(Revised Site Plan & Tree Preservation & Replacement Plans)

Re: Rezoning Application of The Woodbery Group, LLC concerning a 4.71 Acre Tract located on the west side of Bell Drive. (No. Z17-016)

Bell Drive Community

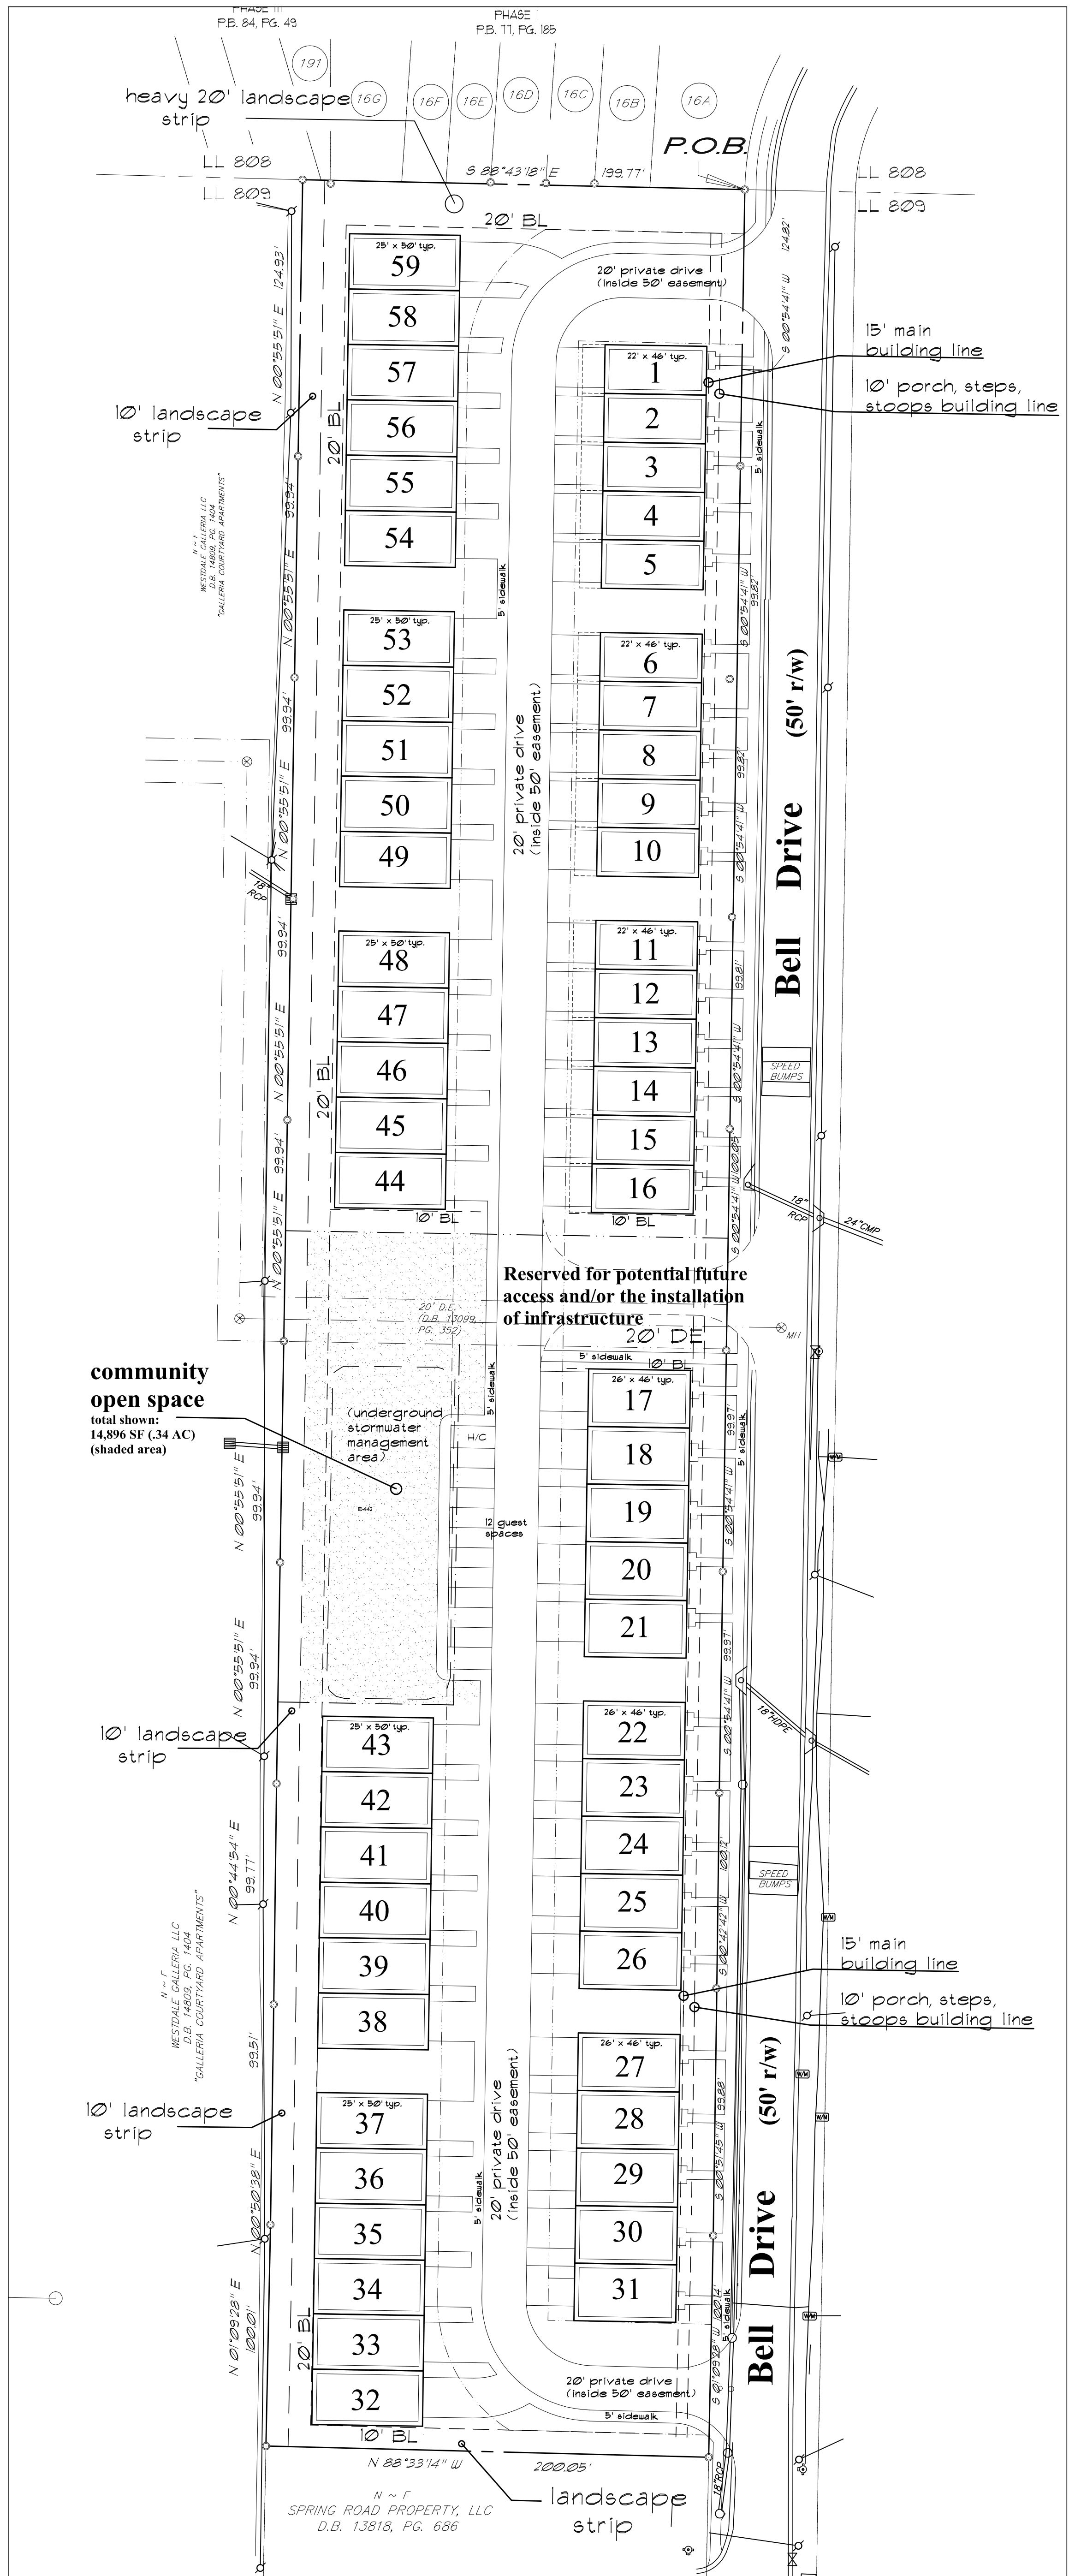
In comparison to the previous revised site plan, the enclosed Revised Site Plan reflects that both the north and south entrances are positioned in accordance with direction from the Public Works Director which includes a twenty foot (20’) private drive within the confines of a fifty foot (50’) easement. By virtue of this modification, specifically with respect to the southern entrance, the enclosed Revised Site Plan shifts units 17 – 31 five feet (5’) to the north which commensurately decreases the side setback off of the “Reserved Future Right-of-Way” for unit 17 to ten feet (10’) instead of the original fifteen feet (15’). Unit 16 also reflects a ten foot (10’) side setback which is also driven by the Public Works Director’s recommendations.

In addition to the foregoing, and in order to clearly state what we understand is the position of staff regarding the calculation of driveway lengths, as covered in the September 26, 2017 stipulation letter, it is our understanding that the calculation of driveway length is measured from a position flush with the garage doors to the five foot (5’) sidewalk in order to achieve driveways which are a minimum of twenty two feet (22’) in length and in order to accommodate the parking of at least two (2) additional vehicles within said driveways.
